Amendments to the Drawings:

REMARKS

2/9
ANNOTATED MARK-UP DRAWING
REPLACEMENT SHEET

FIG. 1a

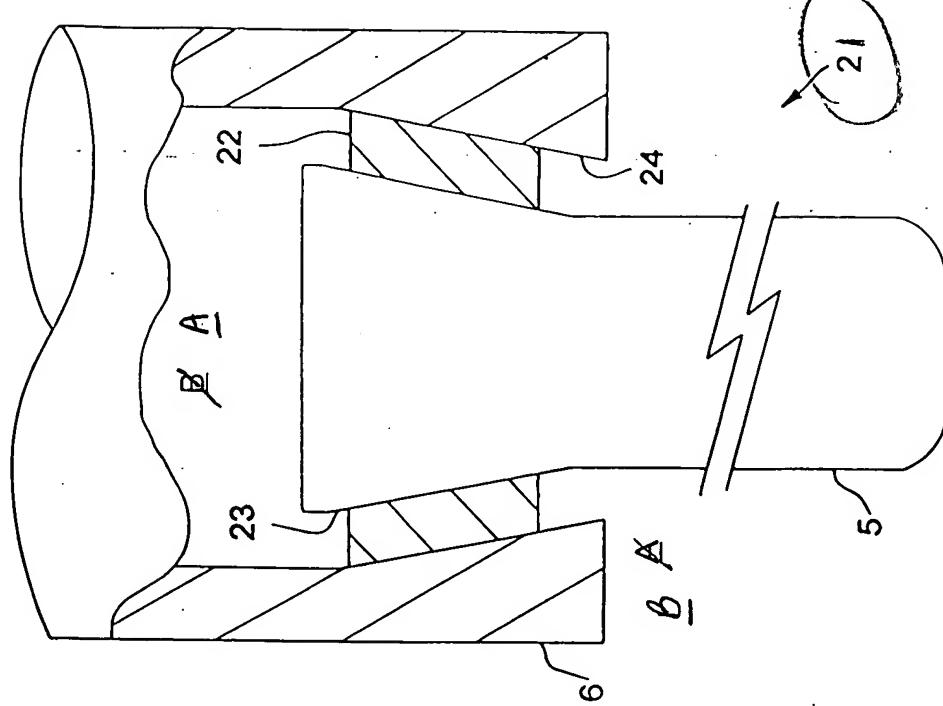
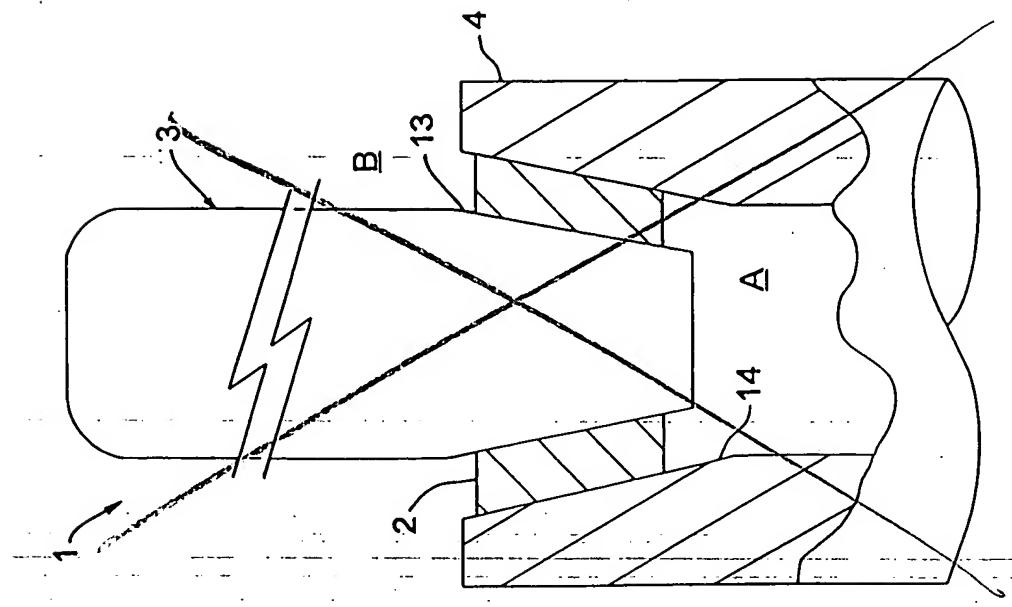
For the previous drawing depicting FIGS. 1a and 1b as originally filed (and as shown on the "Annotated Mark-Up Drawing"), Applicants are requesting to delete prior FIG. 1a as it appears redundant with FIG. 1 except for size, as noted in the Office Action. Applicants are also requesting that the remaining figure on the sheet be rotated 90 degrees and also relabeled as the new FIG. 1a. Further, Applicants are requesting that areas previously identified by "A" and "B" respectively, be reversed as also suggested by the Examiner in the Office Action. Reference numeral "2" has also been changed to – 21 – to avoid any potential confusion with reference numeral "2" also appearing on FIG. 1.

Applicants have herein requested amendment of the drawing sheet previously depicting FIGS. 1-a and 1-b, so that FIG. 1-a as originally submitted is deleted, and that FIG. 1-b as originally submitted is rotated 90 degrees and relabeled as "FIG. 1-a". Applicants have also requested that joint "2" on the previous drawing sheet be amended to a new reference numeral – 21 --, so minimize confusing that might arise relative to FIG. 1, which uses the reference numeral "2" in relation to the girdle member. Applicants have also reversed the locations identified as "A" and "B" on new FIG 1-a, to be consistent with use in FIG. 1. However,

Applicants wish to point out that the use of the letters "A" and "B" in the original figures was reversed intentionally, in that location "B" was deemed to be an area of higher pressure relative to area "A". Appropriate amendments in the Specification, as suggested in the Office Action, have also been made to implement these changes in the figures. No new matter is involved.

Rotate
90°
